Groundwater Application Review Summary Form

Application # G- 18690

To: Kristopher Byrd, Well Construction and Compliance Section Manager
From: Joel Jeffery, Well Construction Program Coordinator
Subject: Review of Water Right Application G-18690
Date: March 14, 2019

TO: Water Rights Section Date 1/23/2019
 FROM: Groundwater Section Jen Woody
 Reviewer's Name
 SUBJECT: Application G- 18690 Supersedes review of n/a
 Date of Review(s)

Figure 3. Stream depletion POAs 1,2,3 and Mission Creek

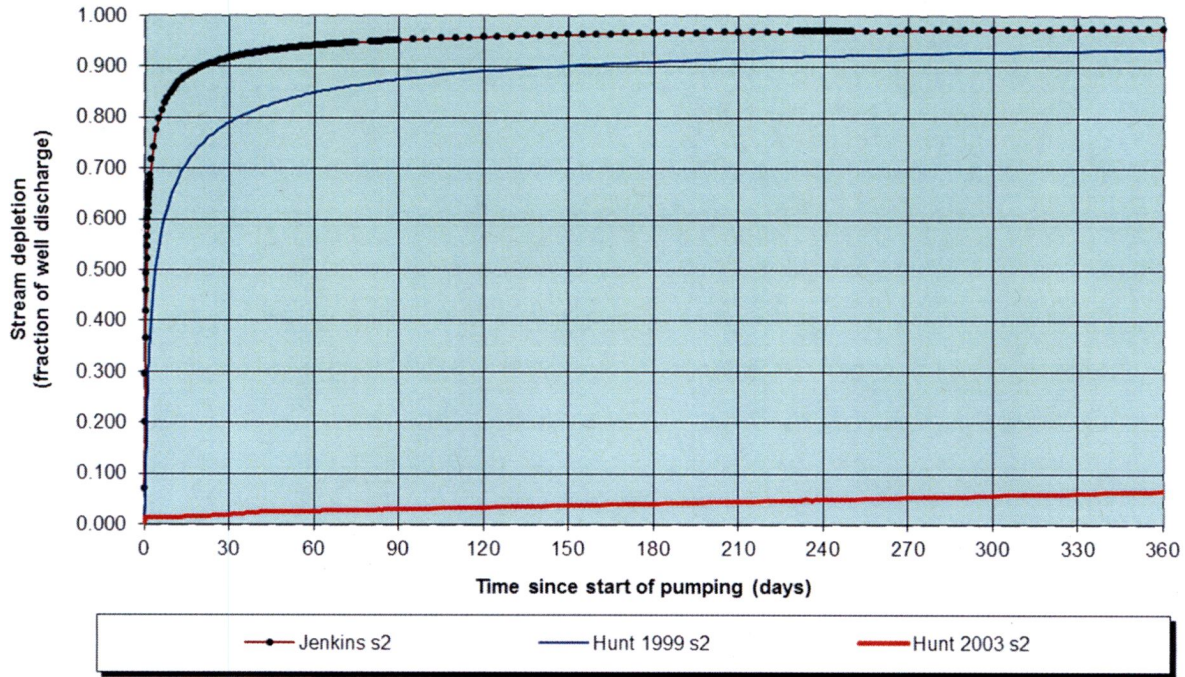
Well yield in 4S/2W-19, 20, 29, 30 ranges from 20 to 1620 gpm, with a median yield of 100 gpm. The requested rates of 9.2 cfs (4,140 gpm) for wells 1/MARI 1243, 2/MARI 1337, and 3/ MARI 1221 may be possible as a combined rate of the proposed POAs.

Water level data from state observation well MARI 2331 indicates seasonal fluctuations of about 20 feet, but relatively stable conditions over the last 50 years for shallow wells (see hydrograph in Fig. 3). The thin, lenticular geometry of the water-bearing zones and the large proposed rate indicate that water-use reporting and water-level measurement conditions are prudent (Conlon and others, 2005).
